Re: Transmittal Letter
Site Location: Arrow Rentals
187 North L Street, Livermore, CA 94550

Project No.: 1262.2
Project Name: Sullins Property (L St.)

RE: Report of Findings
Arrow Rentals, 187 North L Street, Livermore, CA

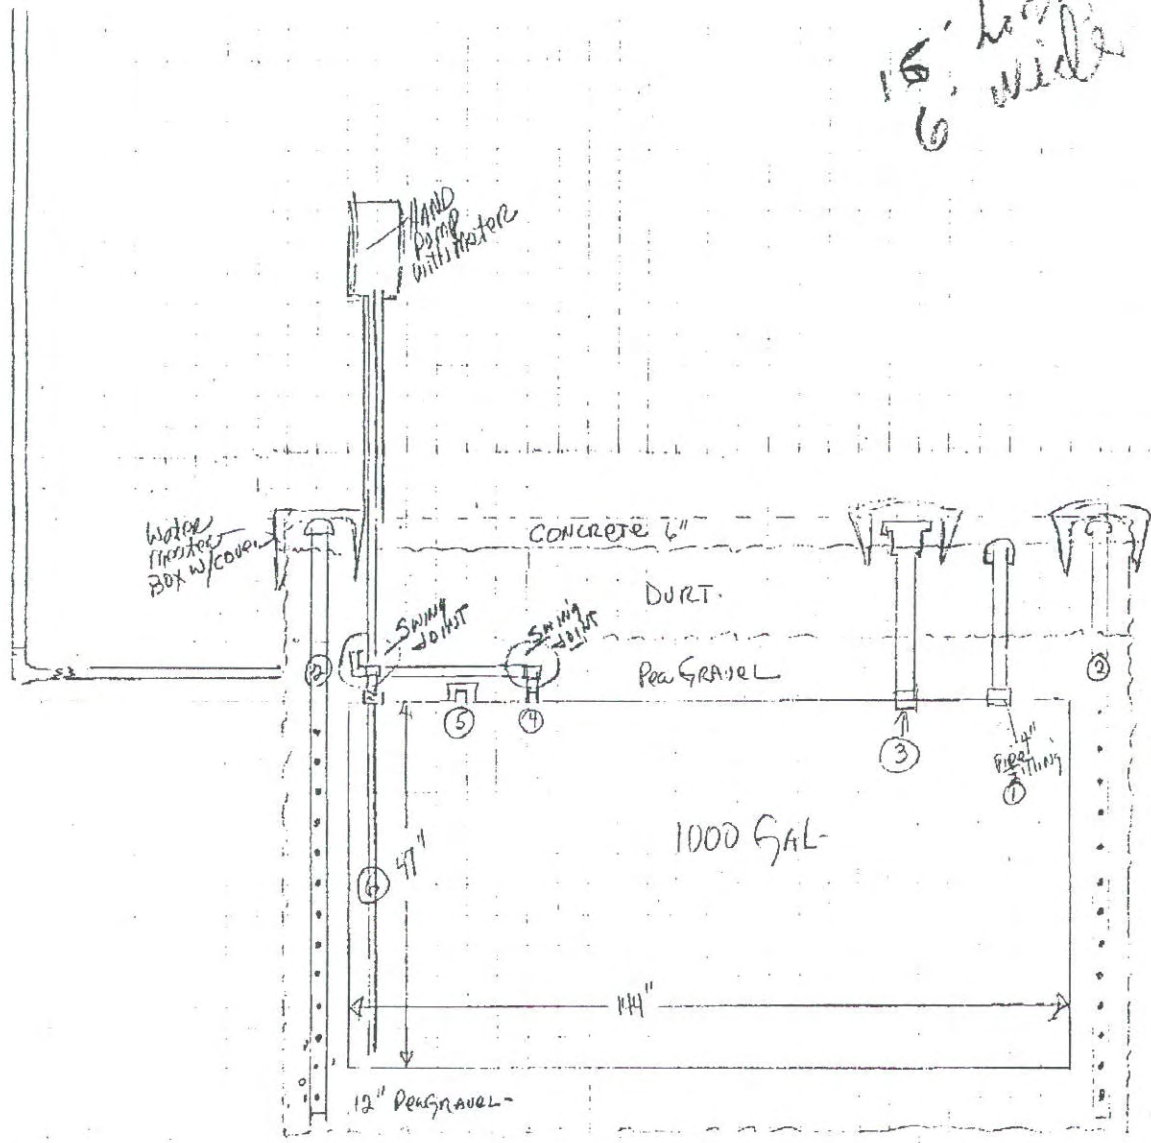
Discussion: The soil samples from B-1A should have shown the effects of the Pitcock Spill due to the boring's proximity to the vapor well & UST. But the soil samples from 10 to 35 feet below grade surface (bgs) were non-detect for TPH-G (elevated detection limits of 10 mg/kg noted, but text states ND <5 ppm?). WWC stated that water was poured into the vapor well and this could account for a "washing" of the soil. The time and gallonage presented in the report are an assumption and it is unlikely with documented clays and silts in the predominant gravelly soils that no trace would remain at shallow depths. WWC's statement that significant (>100 ppm TPH) soil will be found under the tank contradicts their Figure 5 drawing in which only the 350 mg/kg at 40 feet is noted. It is likely that the soil column in the area of the vapor well contains significantly more TPH-G than the samples from B-1A revealed.

UST schematic included in Appendix A.

Project No. 90C 0321A	Arrow Rentals 187 North L Street Livermore, California	APPROXIMATE SOIL CONTAMINANT PLUMES	APRIL 1991
Woodward-Clyde Consultants			FIGURE 7

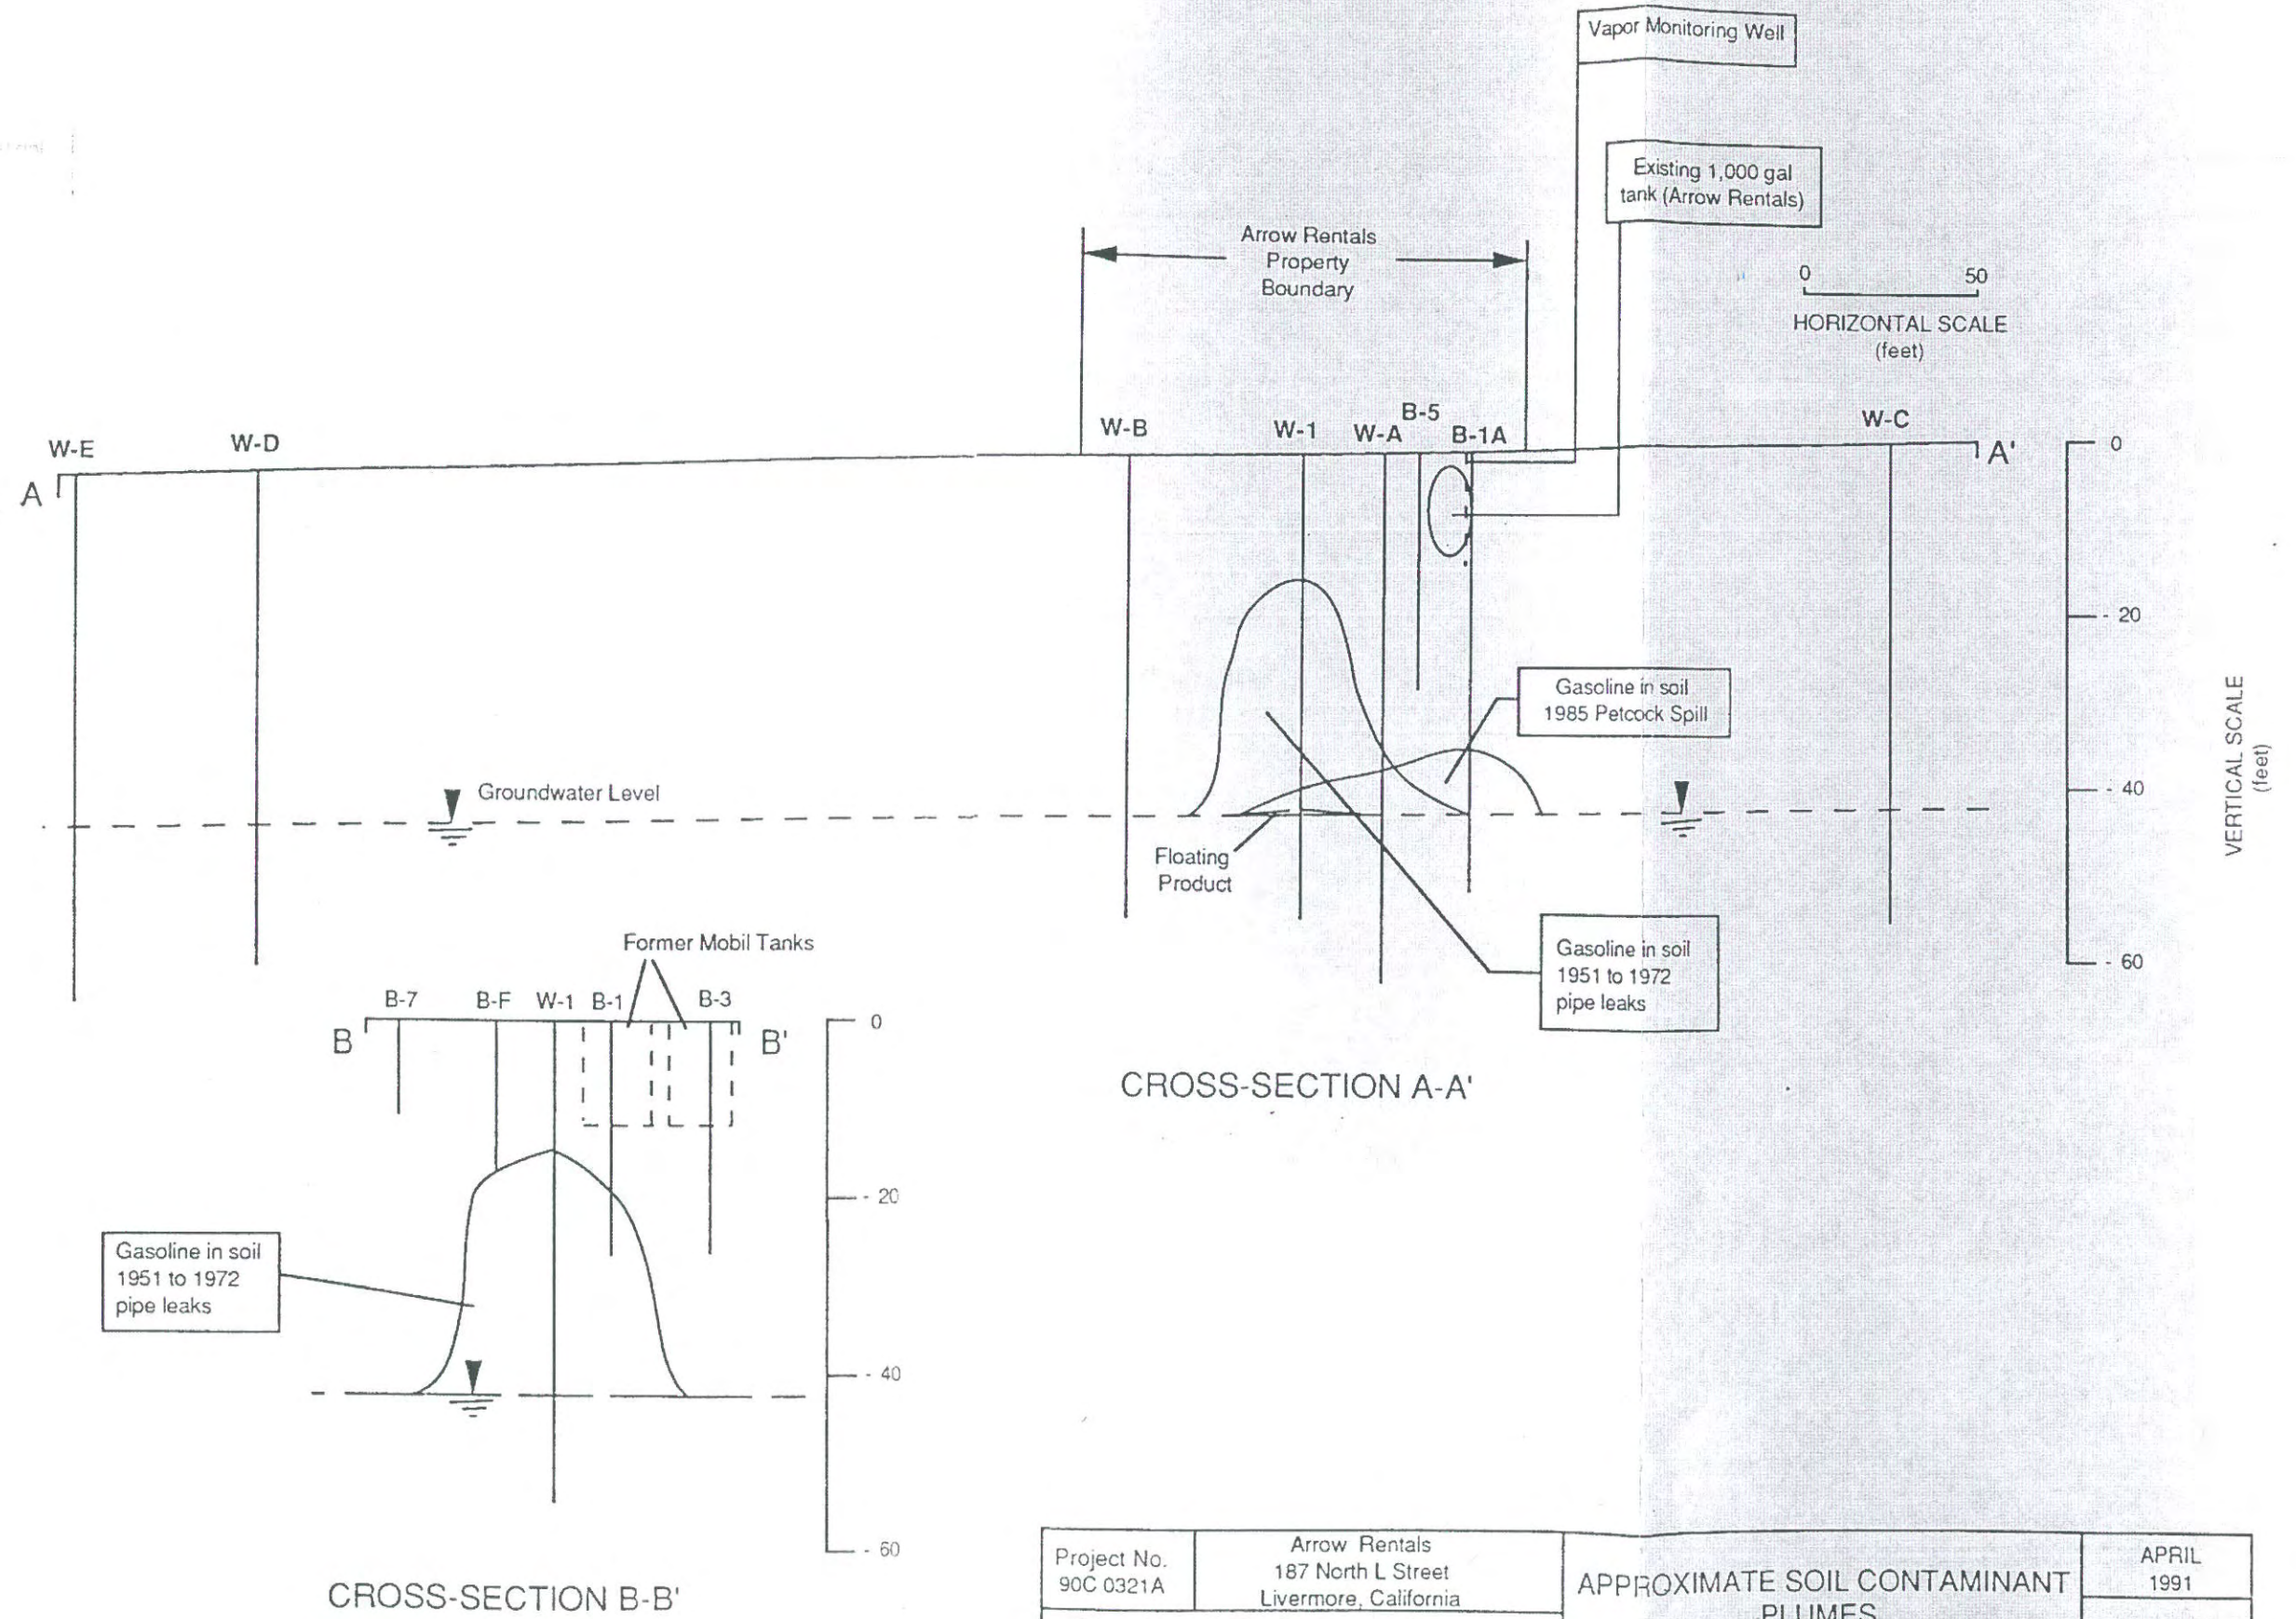
- 2) In Figure 7, Cross Section detail B-B' the soil plume is shown in limited extent laterally from well W-1.

Discussion: W-1 was placed in the down gradient location of the Pitcock release. Significant soil contamination was discovered in this borehole at depths extending from 15 -55 feet bgs. The soil plume is therefore centered on this boring as a piping release location. Borings B-1, B-2 and B-3 were placed in or adjacent to former UST excavations in the central portion of the site. The soil samples from these borings were only taken at a maximum depth of 25 feet bgs and in each case the 25 foot sample contained detectable TPH-G – 220, 1.7 and 1.3 mg/kg, respectively for the three boreholes. It is not known why these boreholes were not advanced deeper or why subsequent investigations did not define the vertical extent of the plume in these locations. It is possible that the USTs were the source of these detections and that significant contamination remains undefined in these areas. If a lithologic factor is responsible for lateral dispersion at 25 feet bgs then the plume could be much greater than depicted by WWC. In any case, the plume shown

on cross section B-B' should have been laterally extended to the base of B-3 but it isn't as depicted.

- 3) In Figure 7, Cross Section detail B-B' the soil plume is shown in limited extent laterally from well W-1.

Discussion: The soil plume in Figure 7 does not extend laterally to the location of boring B-7 that was placed adjacent to the dispenser island at the northwest corner of the parcel. Boring B-H was installed adjacent to the dispenser island in 1992 (and after the WWC 1991 report). Like borings B-1, B-2 and B-3, the soil samples from B-H were non-detect at shallow depths from 4.5 to 21 feet bgs. But the 26, 31, and 36 feet bgs samples contained 160, 1900 and 8000 mg/kg TPH-G, respectively. It is probable that the soil contamination present in these locations is from water table fluctuation smear. GTI notes that in the WWC report it is stated that groundwater has varied from 20 to 40 feet bgs, and in the Aquifer Sciences Inc. May 2004 report, depth to groundwater was approximately 30 feet bgs. This represents a potential smear height of over twenty feet in which hydrocarbons can become entrained in the soil matrix.
